**CITY OF WEST DES MOINES
STAFF REPORT COMMUNICATION**

ITEM: Cross Creek, 2475 SE 1st Street – Approve a Preliminary Plat to create twenty-three lots for Single Family Residential development, one outlot and one street lot – Savannah Homes, Inc. – PP-006173 -2023

PRELIMINARY PLAT CROSS CREEK

CASE NUMBER PP-006173-2023

PRELIMINARY PLAT CROSS CREEK

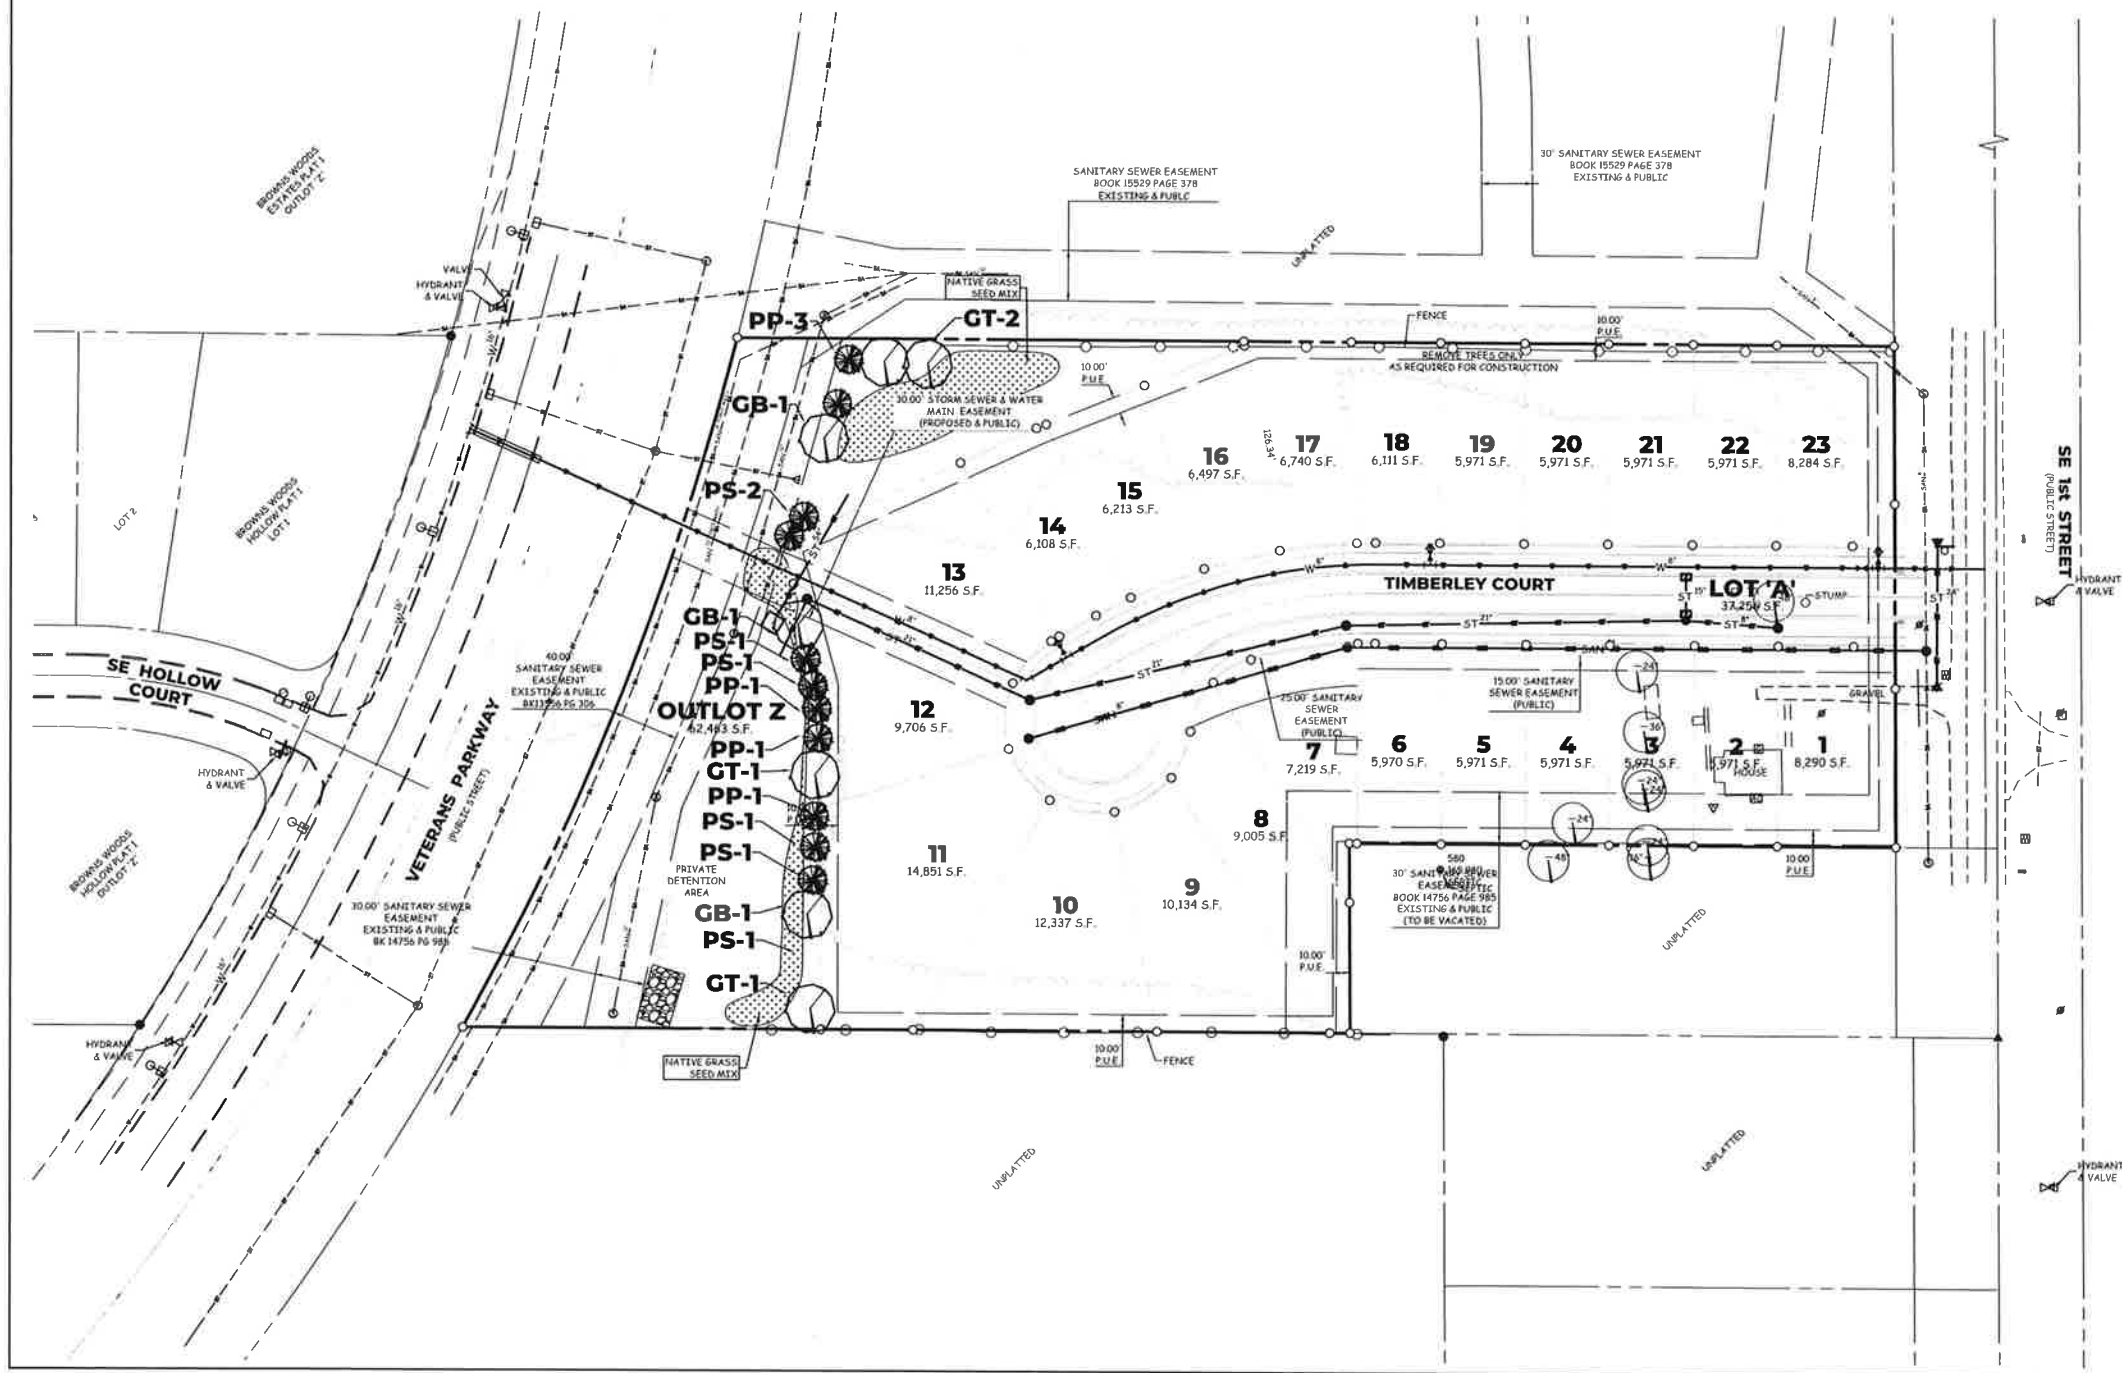
2. **Landscape Buffer:** A landscape buffer is desired along Veterans Parkway to soften the harshness of pavement at the ultimate width and to mitigate impacts on Lots 11, 12 & 13 of the amount of traffic expected on the roadway. Due to the limited depth of lot 12, Staff raised concerns with the buffer consuming essentially all of

Lot 12's rear yard since no structures, including decks, patios, play structures, sheds, etc. are allowed in a designated buffer. Due to the depth and shape of Lots 11 and 13, the buffer would not have as detrimental effect on the usability of the backyard of these lots. Staff discussed with the applicant about placing the 30' double frontage lot buffer that typically would be located within the private lots, to instead be placed immediately adjacent to Veterans Parkway. However, an existing WRA Sewer easement is located immediately adjacent to the Veterans Parkway right-of-way which prohibits the placement of vegetation within the easement area. Adjacent to the easement are then existing wetlands and the anticipated storm water detention facility for the subdivision (see enclosed exhibit illustrating the location of the Veterans Pkwy, WRA easement and detention/wetland area). Instead of placing the buffer within the individual lots and greatly impacting the usability of the limited rear yard of Lot 12, the applicant would like to request a wavier of the 30' landscape buffer. The request is made not only because of the hindrances of the WRA Sewer Easement and wetlands/ detention areas, but also due to the separation between Veterans Parkway to the rear lot line of lots 11, 12, and 13 (approximately 50' at closest point). The applicant is proposing to locate a row of trees (no shrubs) between the rear lot line of lots 11, 12 and 13 and the detention/wetland area. Given the uniqueness of this situation, Staff agrees with the request as we feel it meets the intent of a buffer on a double frontage lot to mitigate the impact of the roadway on the private lot(s) with the added benefit of not creating a situation in which Lot 12 finds out after constructing the home that they have no rear yard to use as they may wish.

****NOTE: WE ARE REQUESTING A WAIVER FROM THE LANDSCAPE BUFFER DUE TO THE SANITARY SEWER EASEMENT WHICH CONTAINS AN 8" FORCE MAIN AND A 72" FORCE MAIN.

1. Applicant acknowledging and agreeing that the Stormwater Management Plan (SWMP) and Storm Water Pollution Prevention Plan (SWPPP) will be updated to address remaining comments to staff's satisfaction prior to proceeding to City Council.
2. City Council granting a waiver of a 30' Landscape Buffer along Veterans Parkway and accepting in lieu thereof the installation of trees in the common area immediately adjacent

to the rear lot line of lots 11, 12, and 13 towards fulfilling the intent of the buffer. Said trees shall be installed prior to the issuance of a final occupancy permit for the last dwelling constructed on lots 11, 12, or 13.
